**RE: Lot 15 Block 6 Unit 2 Unser Cliffs SAD 227
8023 Victoria NW
Grading and Drainage Plan
Engineers Stamp Date 10/18/17 (E10D040)**

RE: **Lot 15 Block 6 SAD 227**
Unser Cliffs
8023 Victoria NW
Grading and Drainage Plan
Engineers Stamp Date 10/16/17 (D10D040)

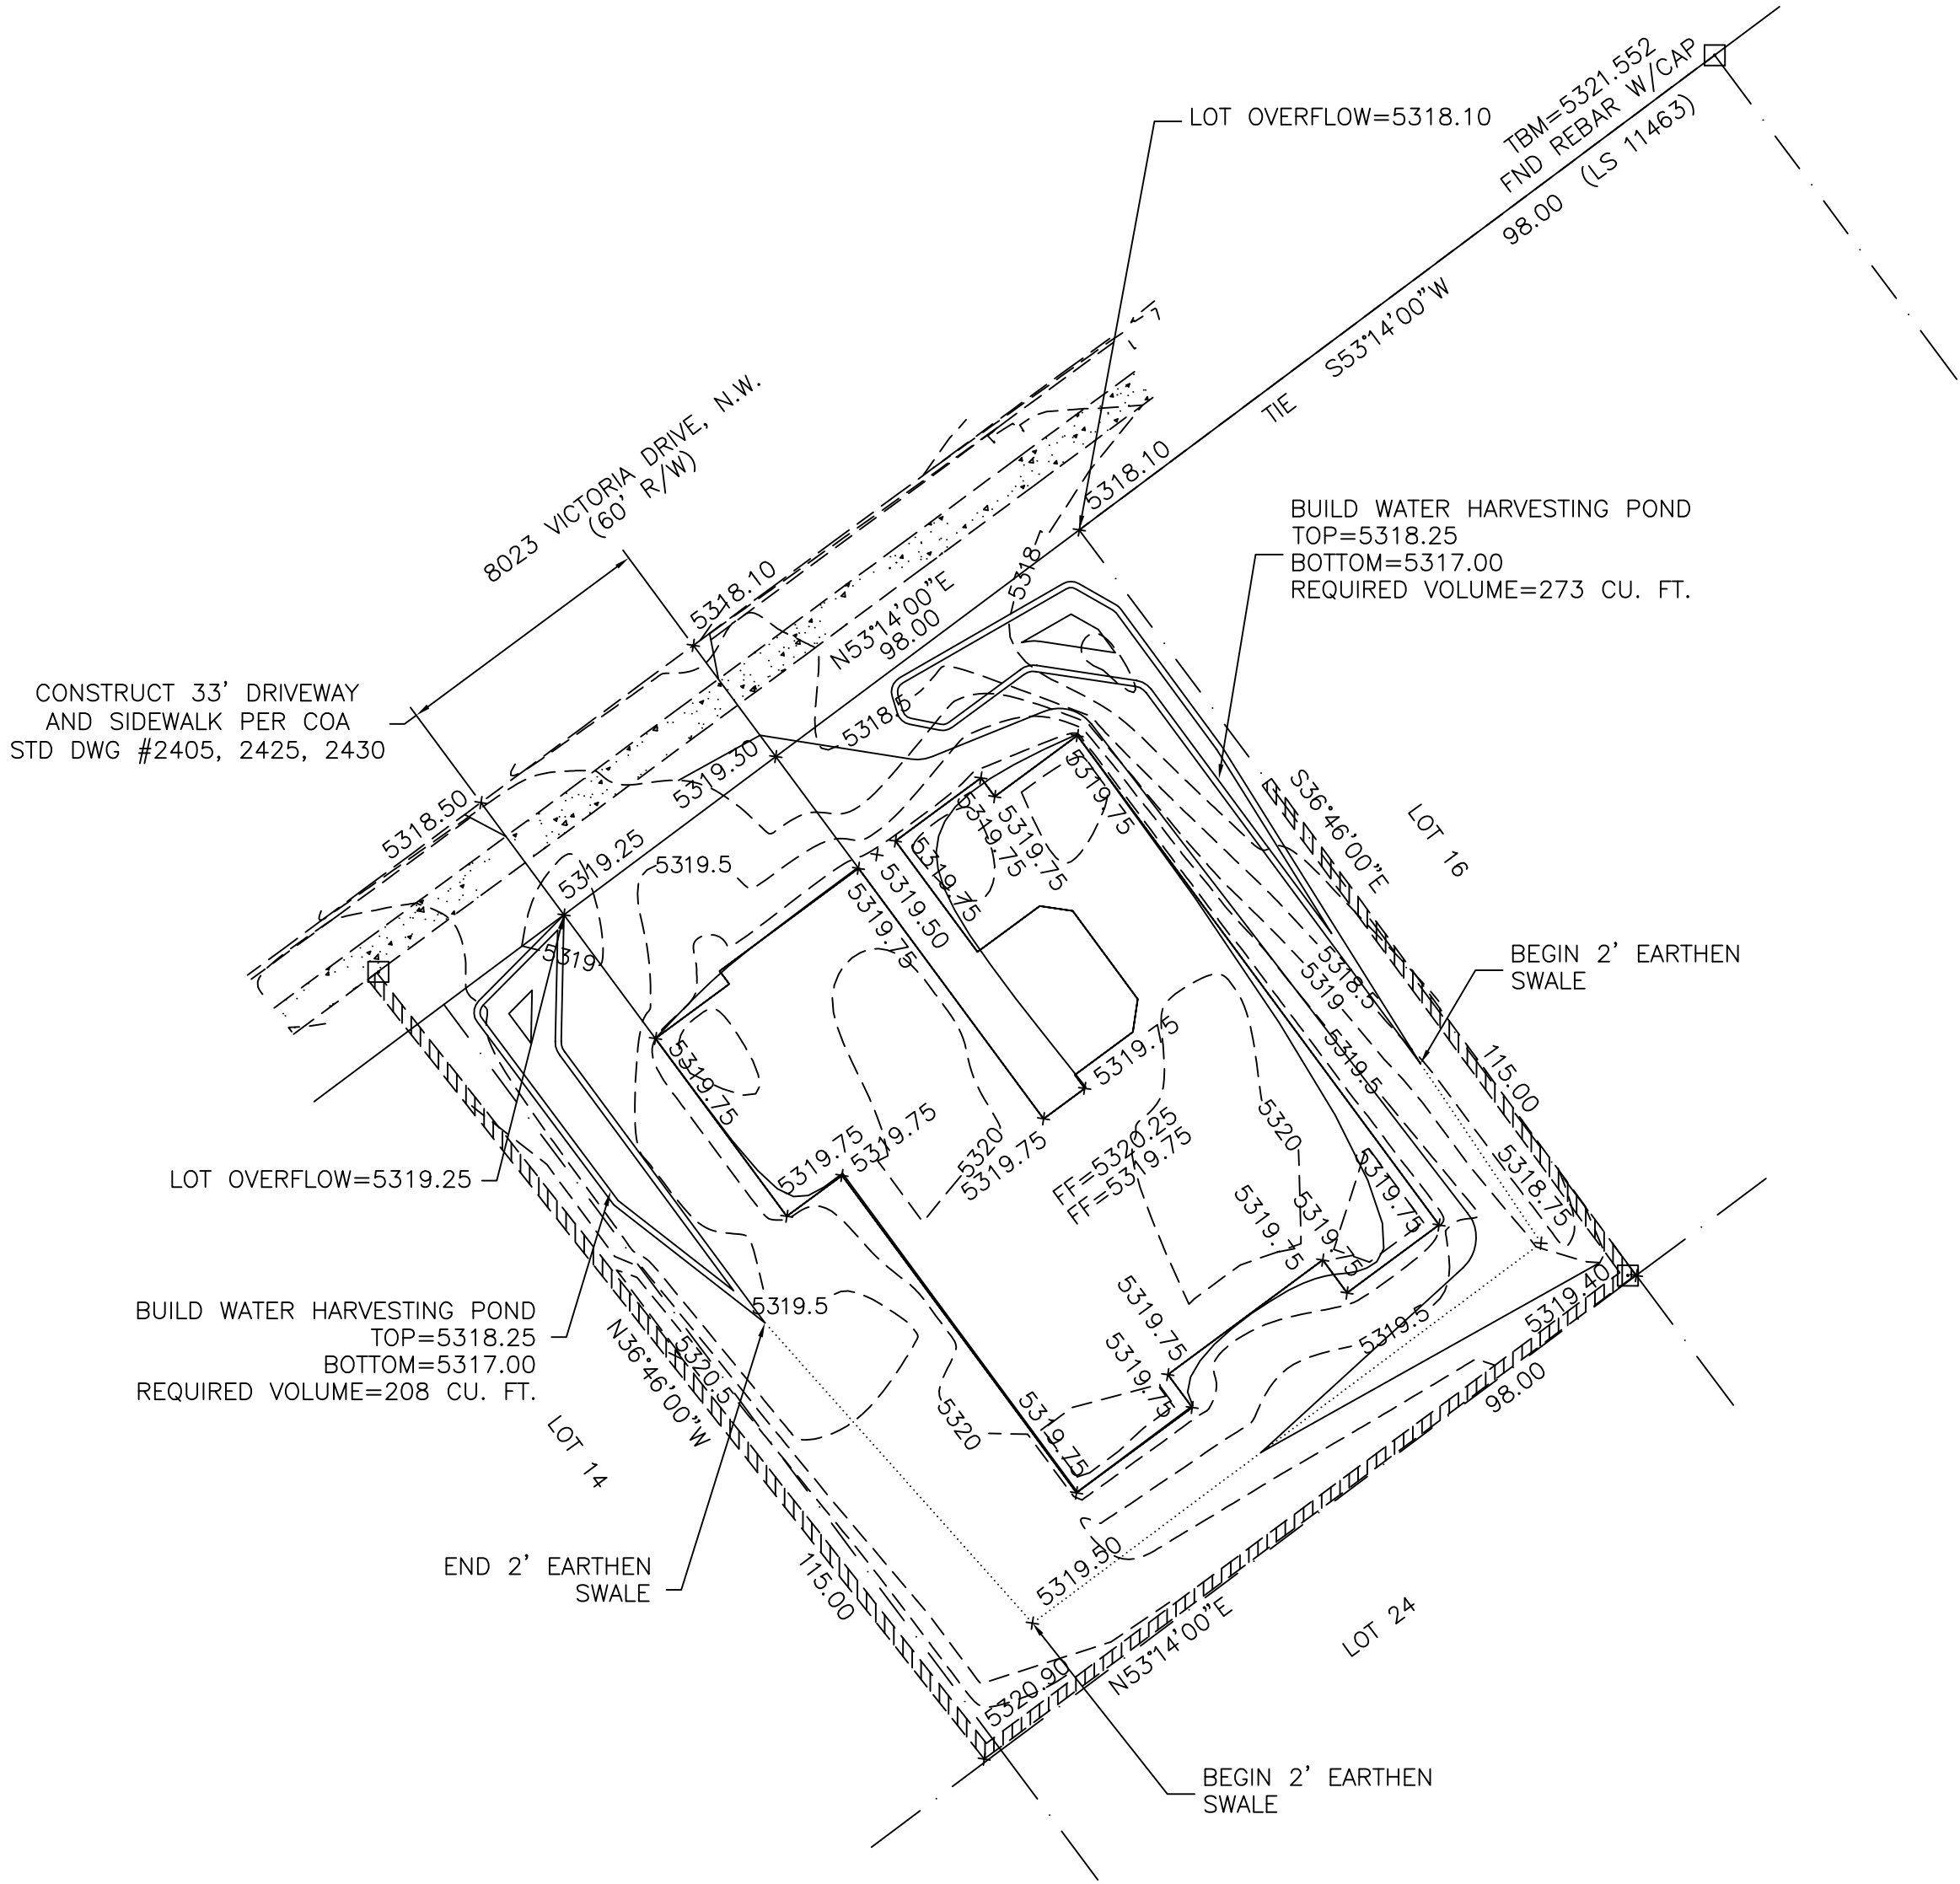
- Provide a statement on the plan stating that this grading plan must be submitted for the application of any garden/retaining walls.

1. ALL SPOT ELEVATIONS REPRESENT FLOWLINE ELEVATION UNLESS OTHERWISE NOTED.
2. ALL SLOPES SHALL BE 3:1 MAX. AND GRAVEL OR NATIVE SEEDING PRIOR TO CO.
- 3.A PAD CERTIFICATION IS REQUIRED PRIOR TO RELEASE OF BUILDING PERMIT.
- 4.ANY ONSITE PERIMETER WALLS MUST CONFORM TO THIS PLAN. A COPY OF THIS PLAN MUST BE SUBMITTED WITH WALL PERMIT APPLICATION

ADDED
